PCN #: 2588

PCN Title: Qualification of Additional Clip Bonding, Lead Frame Structure (Matrix) and Mold Compound, and Qualification of Additional Diodes Internal Assembly & Test Site (SSEC) for Select Discrete Products

PCN-2588 REV1

Figure 1: Comparison of SMB Package Construction for SKY, GPP, Zener and Unidirectional TVS products

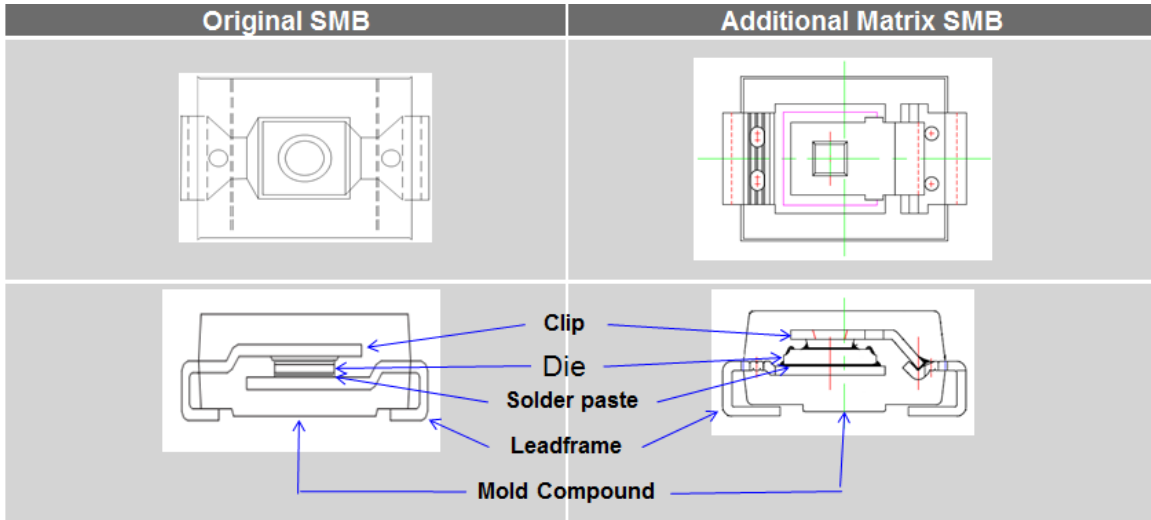
Notification Date:	Implementation Date:	Product Family:	Change Type:	PCN #:
1 June, 2022	1 September, 2022	Discrete	Clip Bond, Lead Frame, Mold Compound, Additional Assembly & Test Site	2588
TITLE				
Qualification of Additional Clip Bonding, Lead Frame Structure (Matrix) and Mold Compound, and Qualification of Additional Diodes Internal Assembly & Test Site (SSEC) for Select Discrete Products				
DESCRIPTION OF CHANGE				
<p>This PCN is being issued to notify customers that in order to assure continuity of supply and to improve assembly manufacturability, Diodes Incorporated has qualified additional clip bonding, lead frame structure (Matrix), and mold compound at Diodes subcontractor Eris Technology Corp. (ERIS) located in Taoyuan City, Taiwan for select discrete products.</p> <p>In addition, Diodes Incorporated has also qualified internal assembly and test (A/T) site (SSEC) located in Shanghai, China as an additional A/T site for select products listed below.</p> <p>Full electrical characterization and high reliability testing has been completed on representative part numbers to ensure no change to device functionality or electrical specifications in the datasheet. Refer to the attached qualification report embedded in this file (to view, download this PCN file then open it with a PDF viewer to see the attached qual report).</p> <p>There will be no change to the Form, Fit or Function of affected products unless specifically indicated (see figures 1 – 5).</p>

IMPACT				
No change in datasheet parameters and product performance				
PRODUCTS AFFECTED				
<p>Please see the affected parts in the following tables and comparison of package construction in figures below. Table 1: Additional lead frame structure (Matrix) Table 2: Additional lead frame structure (Matrix) and additional assembly and test site (SSEC) Table 3: Additional assembly and test site (SSEC)</p>				
WEB LINKS				
Manufacturer's Notice:	https://www.diodes.com/quality/product-change-notices/diodes-product-change-notices/			
For More Information Contact:	https://www.diodes.com/about/contact-us/contact-sales/			
Data Sheet:	https://www.diodes.com/catalog/			
DISCLAIMER				
Unless a Diodes Incorporated Sales representative is contacted in writing within 30 days of the posting of this notice, all changes described in this announcement are considered approved.
